DRAFT VARIATION TO THE TERRITORY PLAN NO 344 WODEN
TOWN CENTRE: ZONE CHANGES AND AMENDMENTS TO THE
PHILLIP PRECINCT MAP AND CODE

STANDING COMMITTEE ON PLANNING AND URBAN RENEWAL

REPORT 3

Figure 3 - CURRENT PHILLIP PRECINCT MAP³⁶

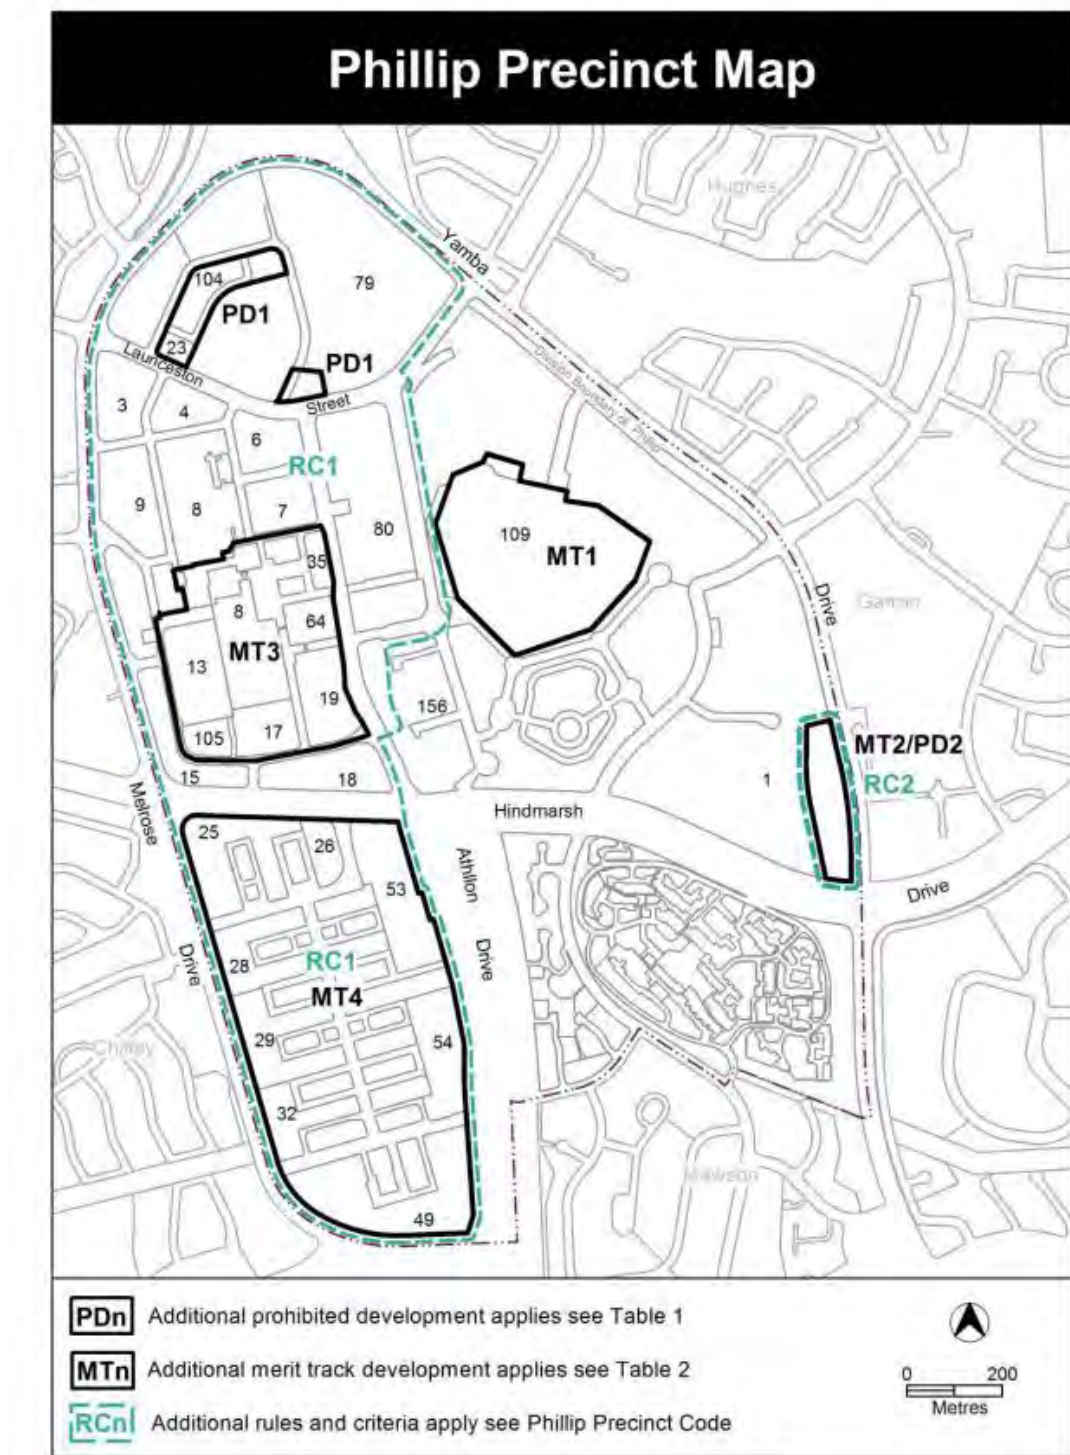
- removal of the built form criterion C21 as it duplicated other provisions within the code
- amended area a) in figure 3 to follow block boundaries along the southern edge;

- 3.28 An example of the lack of explanatory notes was illustrated by the section RC2 being left out of the draft variation documentation which, despite the fact it is indicated in the draft variation that this particular section of the precinct code will be renumbered, because of its absence had at least one submitter thinking it had been removed entirely:

Although the RC2 Yamba Drive Corridor Site is identified in Attachment A of the Precinct Code there are no longer any additional rules and criteria about the number of storeys, setbacks and materials and finishes. There is no explanation about why these rules and criteria have been removed.⁴⁸
